6192 Oxon Hill Hotel

DSP-19033

REQUEST	STAFF RECOMMENDATION
Convert an existing 54,600-square-foot, five-story office building into a 100-room hotel	APPROVAL with conditions

SUBJECT: Detailed Site Plan DSP-19033
6192 Oxon Hill Hotel

BASEMENT FLOOR PARKING LOT LAYOUT AND STRIPING PLAN
 SCALE: 1"=30'

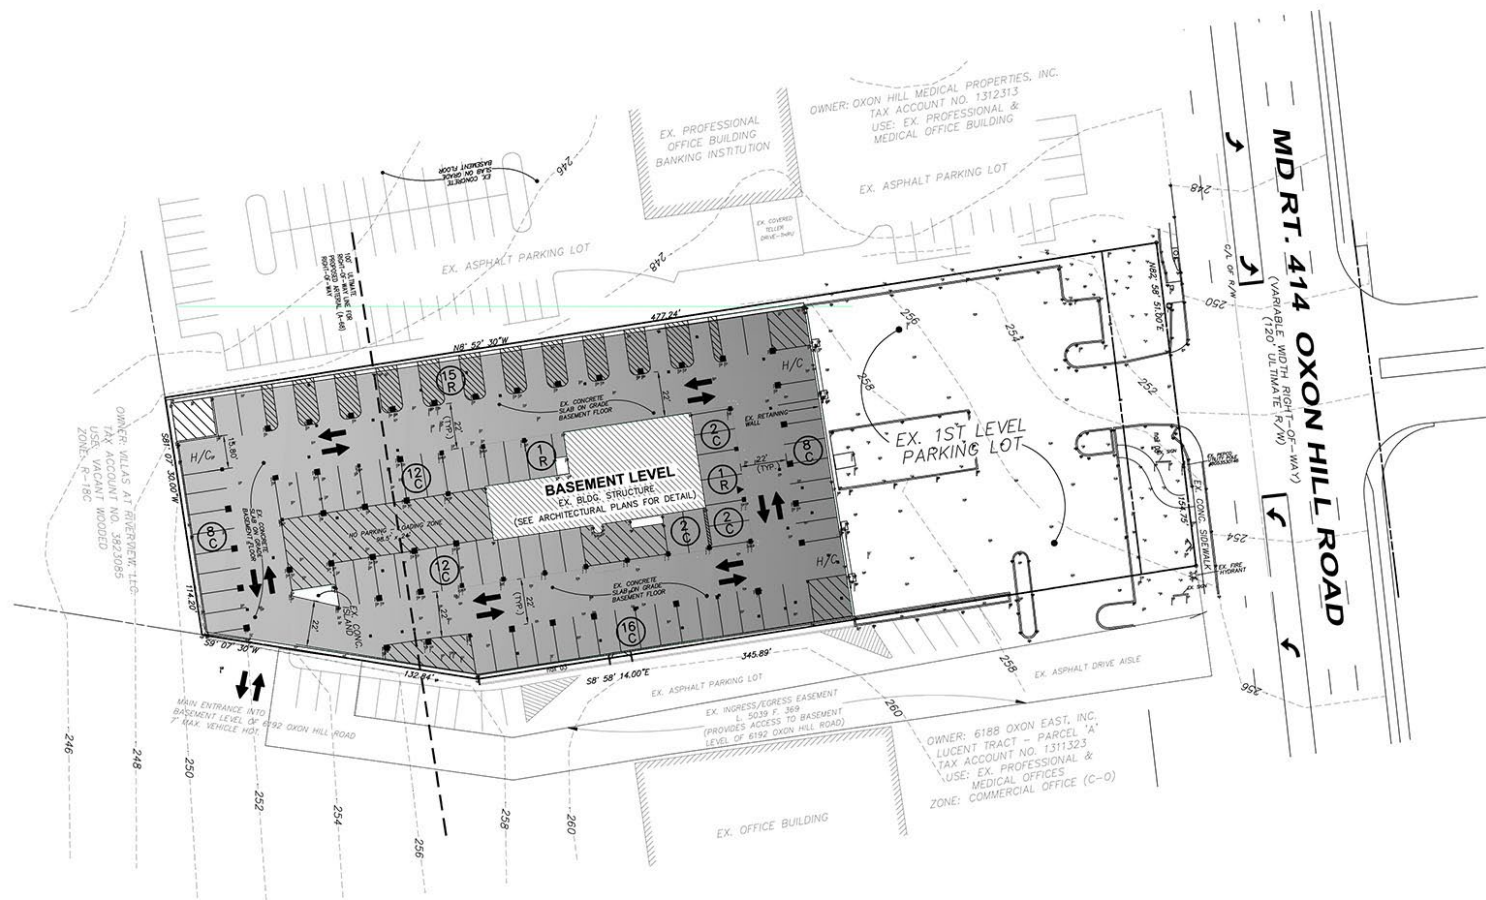
Notes: *The parking and loading schedule is incorrect and lists the wrong number of required and proposed parking spaces and should be corrected.

***The parking spaces proposed within the master-planned right-of-way of A-68, at the southern end of the property, cannot be counted toward the total number of proposed parking spaces and are subtracted from the total number of spaces.

- b. Revised the parking and loading schedule to list the correct number of required parking spaces, provide a break down showing the total number, size, and type of each parking space, and remove the number of proposed parking spaces within the master-planned right-of-way of A-68.

LIGHTING PLAN (UPPER DECK)

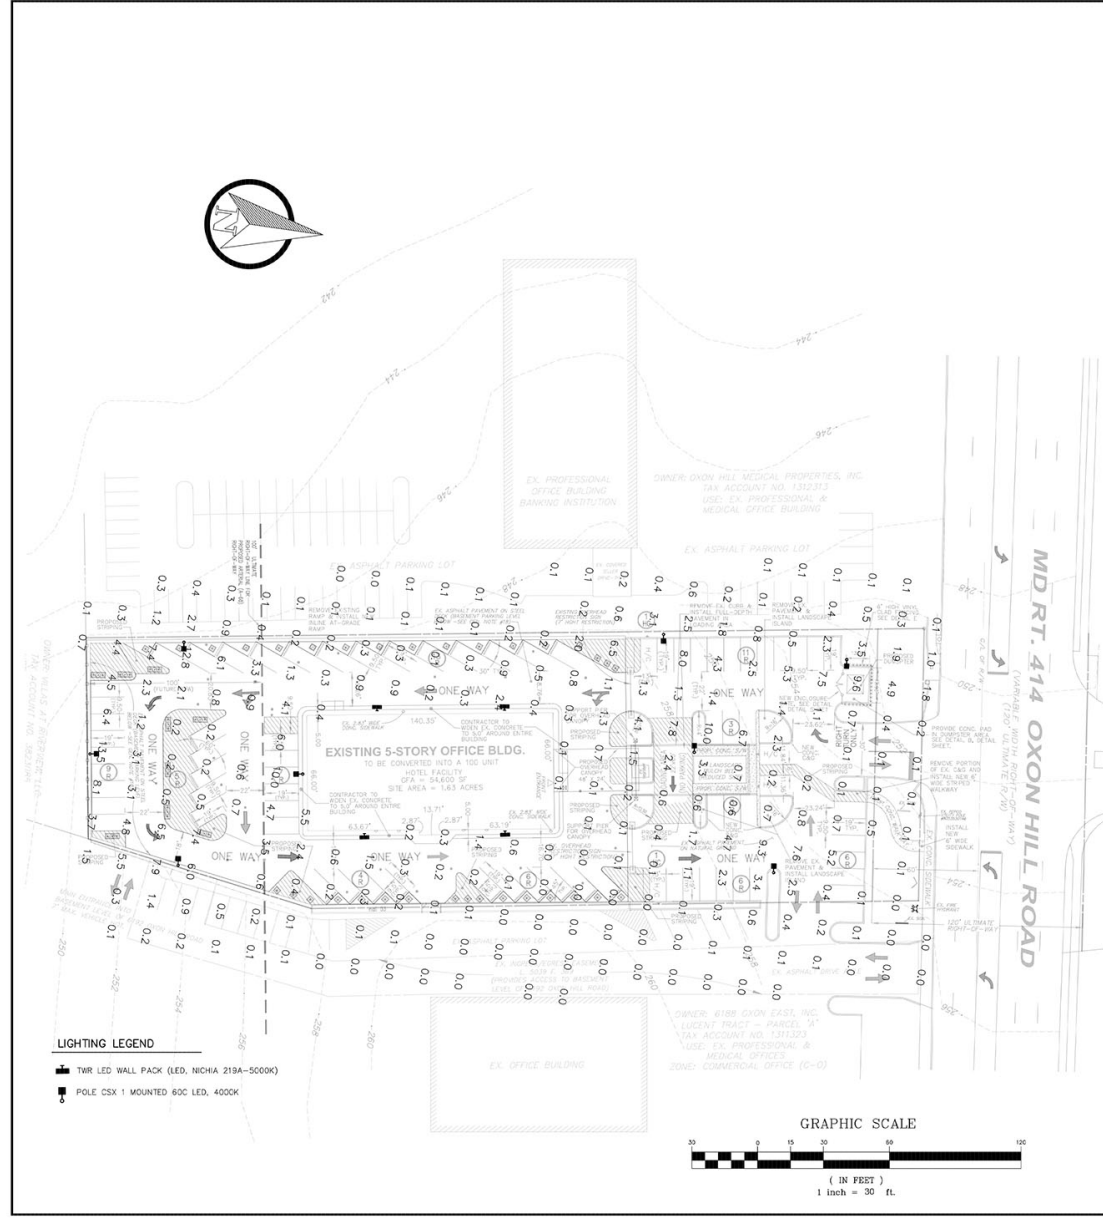
The photometric plan submitted with this application shows building-mounted and existing pole-mounted lighting are proposed on the site, and generally provide sufficient lighting levels to illuminate the site's access, drive aisles, building entryways, and walking paths, and complement the building's façade. However, at the building entrance and the northeast corner of the building, lighting levels drop below recommended levels. In addition, it is noted that details have not been provided for the pole proposed with the pole-mounted lighting and should be provided for clarification. Therefore, conditions have been included herein, requiring the applicant to include improved lighting levels at the building entrance and in the northeast corner, and to provide details and specifications for the proposed light pole.

- c. Provide increased lighting levels at the building entrance and at the northeast corner of the building to illuminate the sidewalk, drive aisle, and building entrance.

- d. Provide details and specifications for the proposed pole-mounted lighting showing the height and character of the pole.
 - e. Provide larger planters for the proposed ornamental trees, or select an alternative species of tree that tolerates a confined soil volume.
